SITE VISIT/MEETING NOTE

Ref: 20-5356
Client/Site: Seacon Ltd/28 Redington Road, Hampstead
Date: 22nd March 2021
Venue: 28 Redington Road, Camden
Attendees:

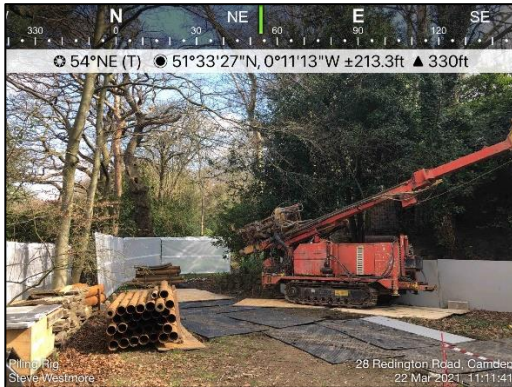
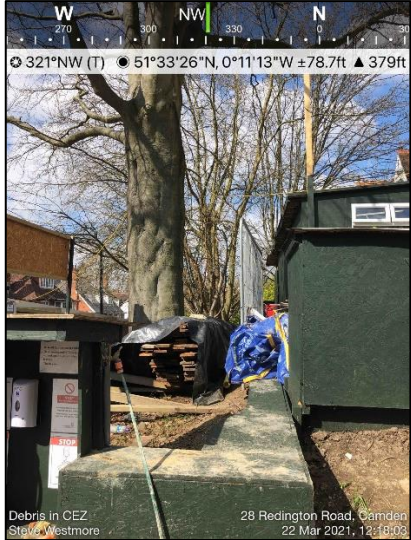
2.0	<p>Tree Protection Measures</p> <p>Tree Protective Fencing (TPF) has been erected around the majority of the trees on site. However, there is evidence of gaps in fencing or material storage within the Construction Exclusion Zones (CEZ). There are several gaps in TPF adjacent T1, T13 and T14 (see plates 1 and 2 below). SW advised that the fencing should be tied into a secure point to avoid egress into the RPAs beyond. TW confirmed that the fencing would be corrected.</p> <div style="display: flex; justify-content: space-around; align-items: flex-start;"> <div style="text-align: center;">  <p><i>Plate 1 - TPF erected around T13 and T14 but with gap (lightweight materials stored on loadbearing system)</i></p> </div> <div style="text-align: center;">  <p><i>Plate 2 - TPF erected around T1 but with gap and lightweight materials in CEZ</i></p> </div> </div>

SW further advised that lightweight materials would need to be removed from CEZs and TPF installed in accordance with the approved documents. SW also advised that should the fencing require setting back due to limited working space then he should be made aware before such changes occur and that the Root Protection Areas (RPAs) and canopies of trees would still require protection.

Plate 3 – Soil introduction adjacent T7-T11 (boundary wall acting as physical barrier to retained trees)

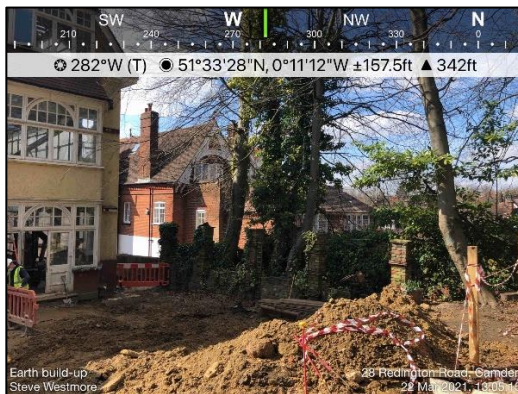
In addition to the above, there was evidence of soil and vehicular movements adjacent to T7-T11 (see Plates 3 and 4 below). SW highlighted that the majority of these trees are subject to a Tree Preservation Order (TPO) and protection is of paramount importance as part of the development programme. SW also confirmed that while there is an existing subbase over the RPAs of these trees, that any vehicle movements in this area would need to be undertaken from on top of a rolling system of temporary ground protection (i.e. TrakMat/DuraDeck). Furthermore, SW advised that the area should be temporarily fenced off to avoid the area being utilised during the development process. TW confirmed that these recommendations would be actioned.

SW highlighted that the low wall adjacent T7-T11 would provide physical protection. However, when the wall is demolished that TPF would need to be installed to ensure that the trees remain free from harm. TW confirmed that the TPF would be erected prior to the wall being demolished.
